Cal Softball Field Renovation Project

Final Environmental Impact Report

June 2024 - State Clearinghouse Number: 2022110035

Figure 1. Trails,
Open Space & Preserves

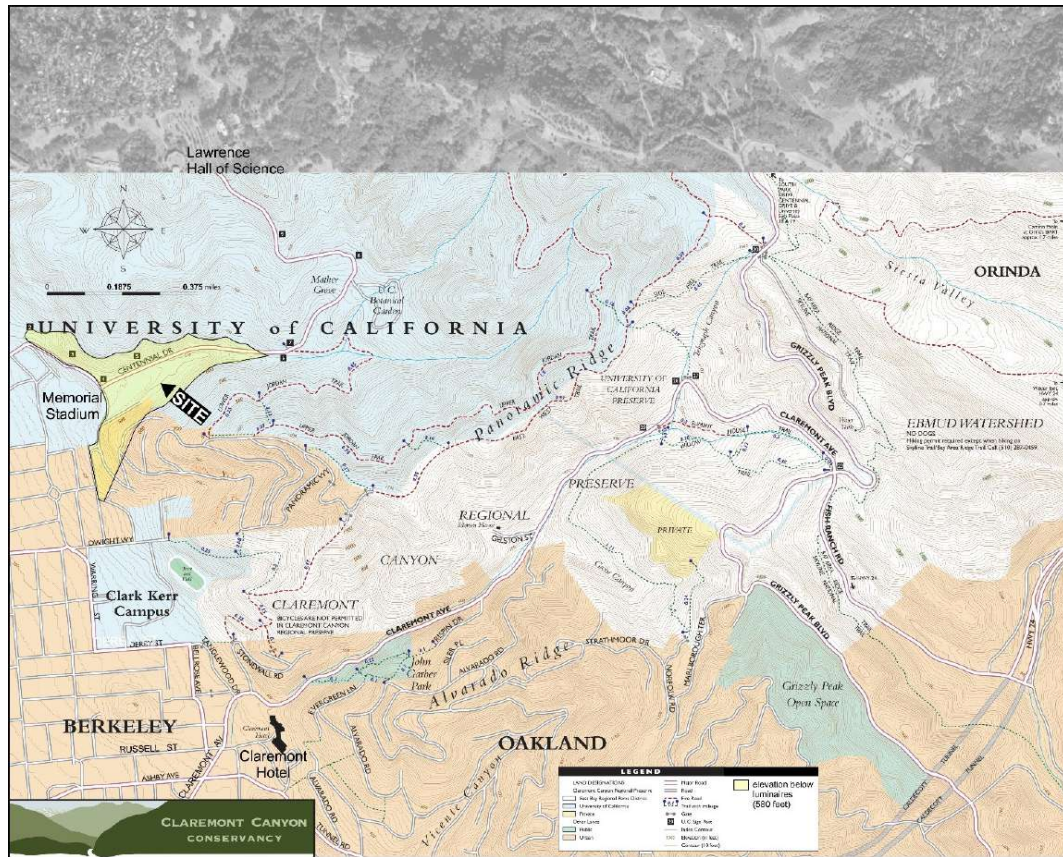
The area east, northeast, south and southeast of the softball field contains open space preserves and limited developed land uses. With the exceptions of UC Berkeley sports lighting (i.e., Memorial stadium, Witter Rugby Field, and Cal Softball Facility), the adjoining neighborhood is located in an area having minimal artificial light at the eastern urban fringe (see Figure 2). Several houses are located southwest, south, or southeast of the softball field, in the elevation zone 400-580 feet above msl. In the immediate neighborhood of the softball field, houses are located within 350-1,130 feet (110-350 meters) of the centerfield wall (see Figure 3). Additional houses are located at or above the elevation of the proposed luminaries, many but not all being shielded by intervening terrain. [See Final EIR Appendix A, Public Comment on Draft EIR, for Letter B5 Figures 1 and 2.]

Figure 3. Neighborhood and
Parcels near the Project Site

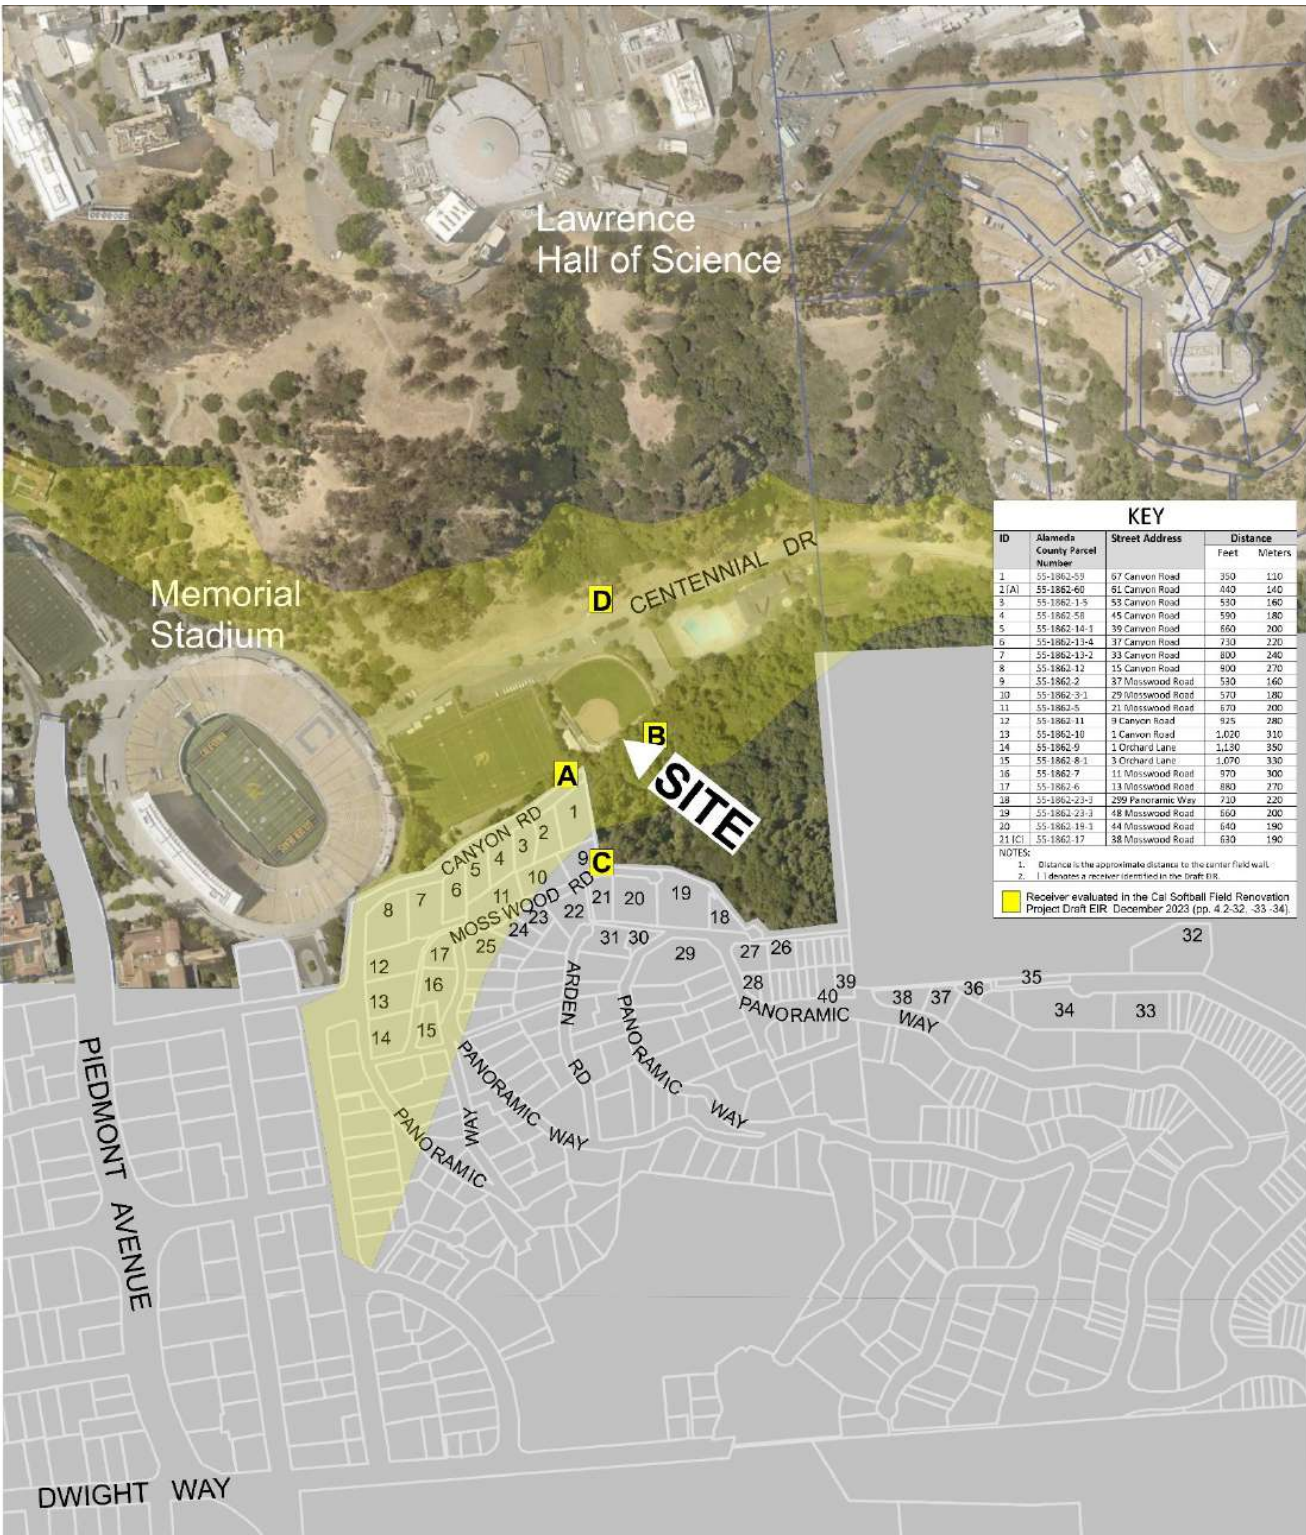
The area east, northeast, south and southeast of the softball field contains open space preserves and limited developed land uses. With the exceptions of UC Berkeley sports lighting (i.e., Memorial stadium, Witter Rugby Field, and Cal Softball Facility), the adjoining neighborhood is located in an area having minimal artificial light at the eastern urban fringe (see Figure 2). Several houses are located southwest, south, or southeast of the softball field, in the elevation zone 400-580 feet above msl. In the immediate neighborhood of the softball field, houses are located within 350-1,130 feet (110-350 meters) of the centerfield wall (see Figure 3). Additional houses are located at or above the elevation of the proposed luminaires, many but not all being shielded by intervening terrain. [See Letter B5 in Appendix A of the Cal Softball Renovation Project Final EIR for Figures 1, 2 and 3 referenced in the comment.]

Figure 2. Hill Campus Land Use - 1990 LRDP

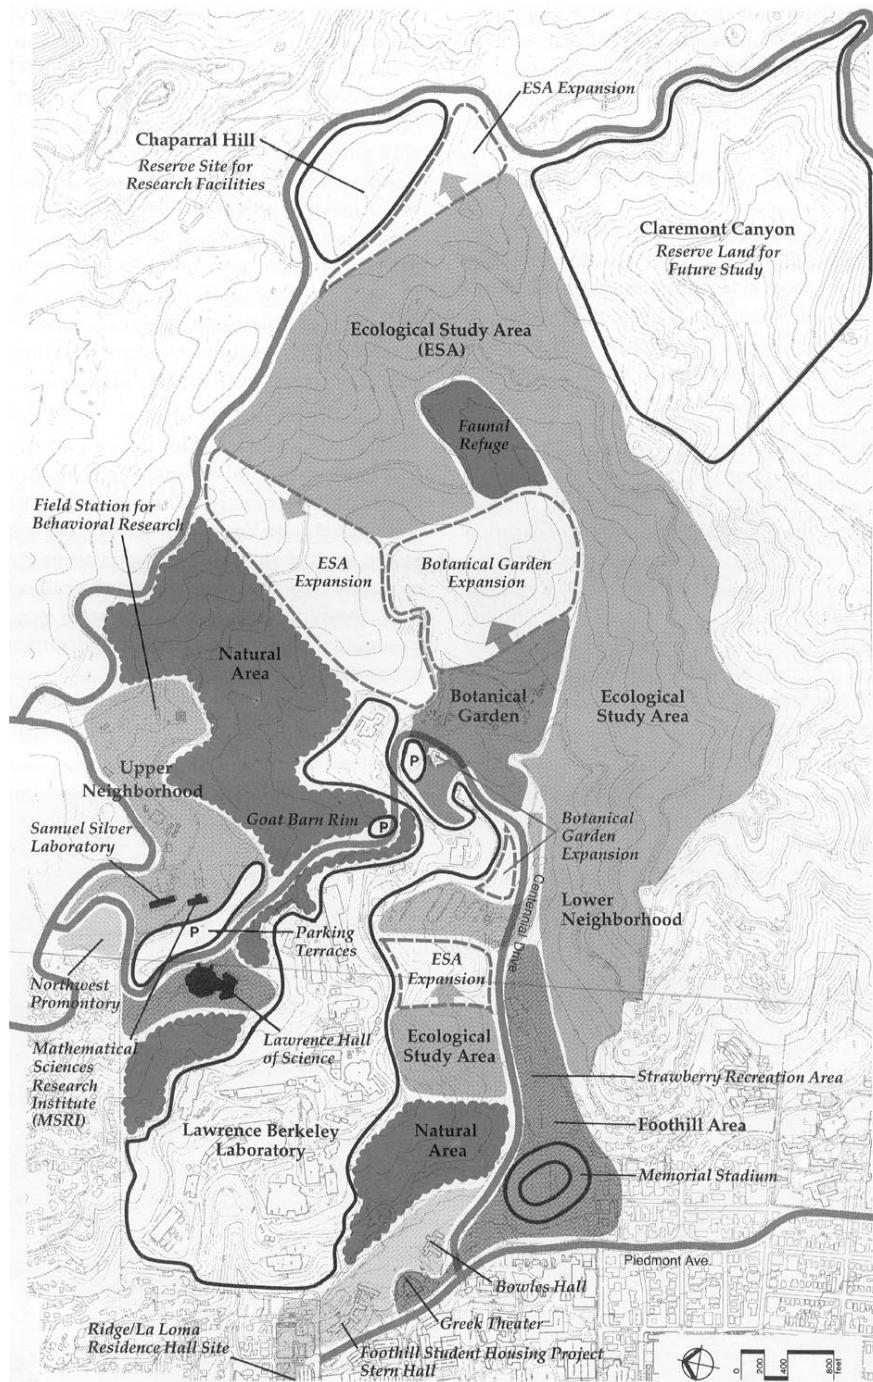
C5-19 Comment. The DEIR did not report examination of the Ecological Study Area. A review of Figures 2 and 3 of the Hill Campus Land Use Map shows the ESA on both sides of the canyon and within 500’ of the project site.

Response. The first feature mentioned in the comment is mapped in Draft EIR Figure 4.3-1, Vegetation Communities and Land Cover Types, and described in Draft EIR Section 4.3, Biological Resources (Subsection 4.3.1.5, Sensitive Biological Resources, Jurisdictional Aquatic Resources), and was therefore considered in our analysis under Impact BIO-3. The Chicken Creek channel mentioned by the commenter is approximately 800 feet east-northeast of the project site and therefore outside the Biological Study Area, but our conclusions would be the same. The proposed project would not impact either feature because no ground disturbance or construction is required in or near the channels, as further described in Impact BIO-3. See also Response to Comment B3-8.

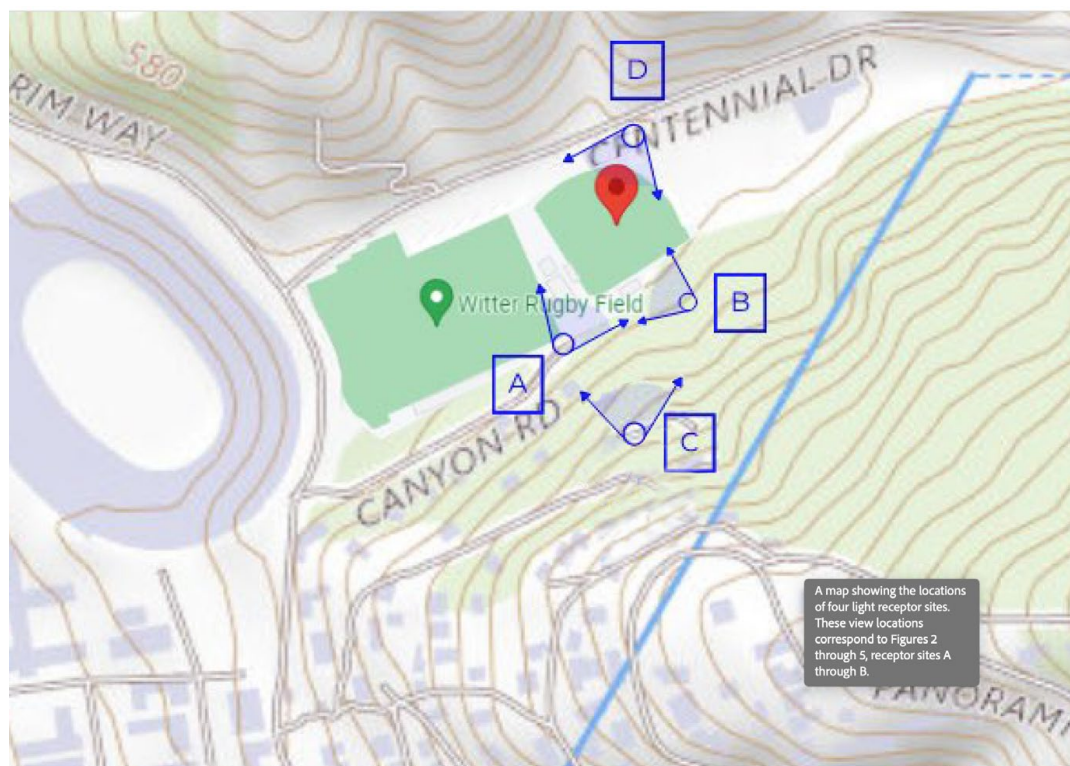
For example, here is a section of the map include in the DEIR appendices showing positions of the “receptor sites” for glare analysis.

Checking the photo provided in the DEIR for site “C” reveals that this map incorrectly identifies the actual physical location of site “C”, which according to the photo is actually many yards further north. An accurate map would show site “C” approximately as shown in the version we have updated below.

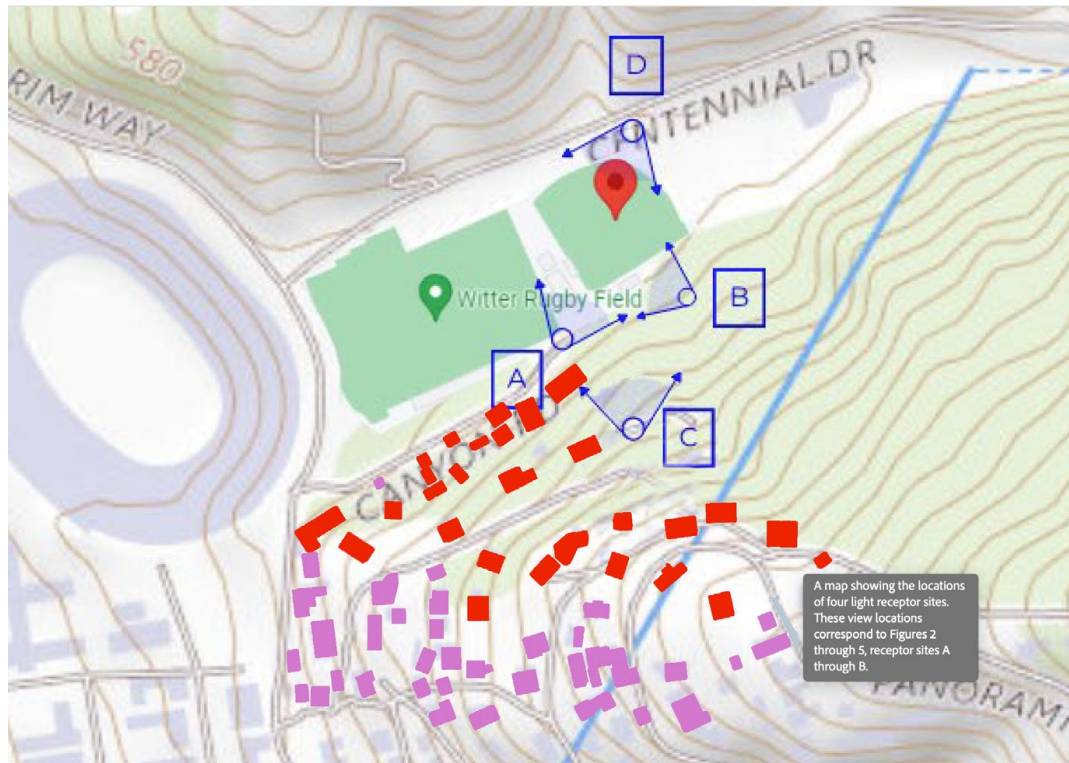
The map used by the Campus here is also very hazy in its depiction of homes in the area. Below is a version of this map with homes included. The homes which may have a view of the project are shown in red.

Screenshot of SoundPlan model illustrating 3D terrain (topography) entered in the model space for softball game noise level assessment in surrounding area.

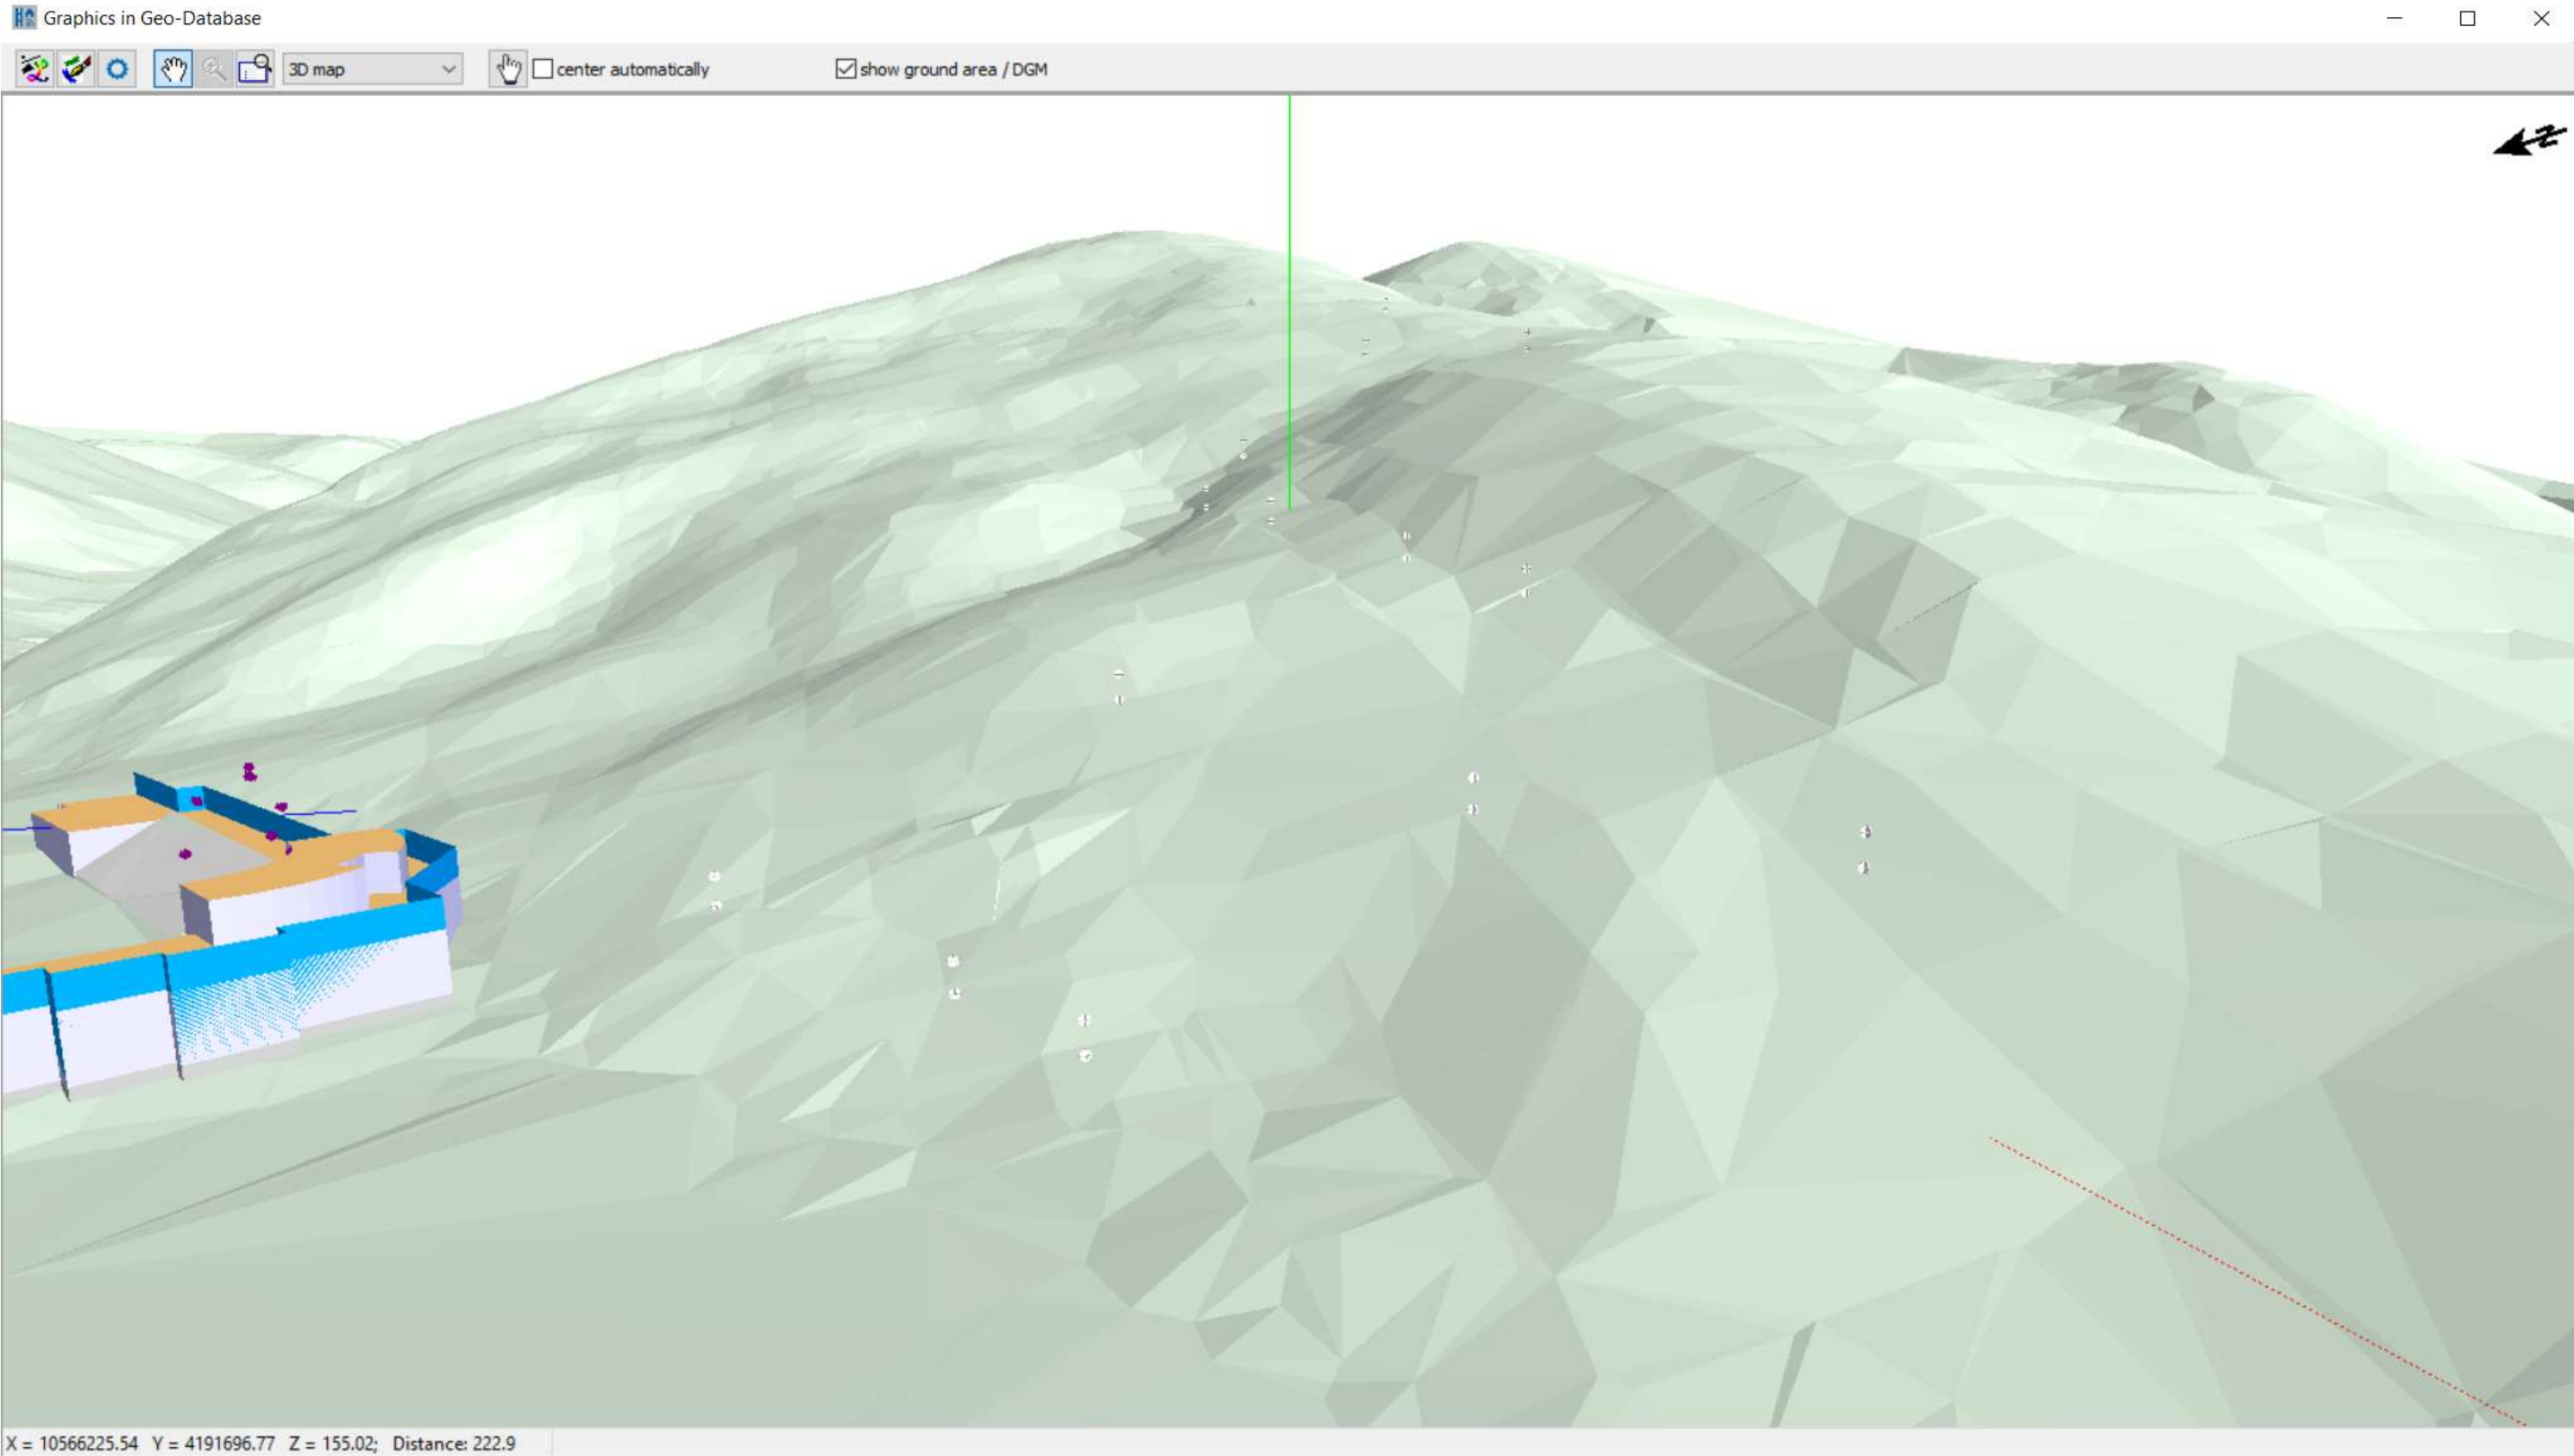
This is also to point out (using DEIR data) the angles of the slopes to the north and south of the softball field. The slopes range from 30-75%, as documented in Figure 4.3. The slopes are relevant to how sound is dispersed or not and how light can be reflected as described by the Panoramic Hill Association's experts.

Response. The ambient noise measurement locations (depicted in Draft EIR Figure 4.5.1) were positioned in direct lines from the existing softball field to the closest residences to the facility. In this regard, suitable and adequate ambient noise data was collected to characterize the existing sound levels at adjacent residential neighborhoods during several softball game events and for periods with no softball games. The topography of the area from the existing softball field to the residential area, and including the residential area, was entered into the three-dimensional sound prediction model (SoundPlan) to ensure that the prediction of sound levels from the renovated softball field at the adjacent residential areas would be accurate. See also Response to Comment B5-40 for additional discussion regarding the consideration of topography in the SoundPlan model.
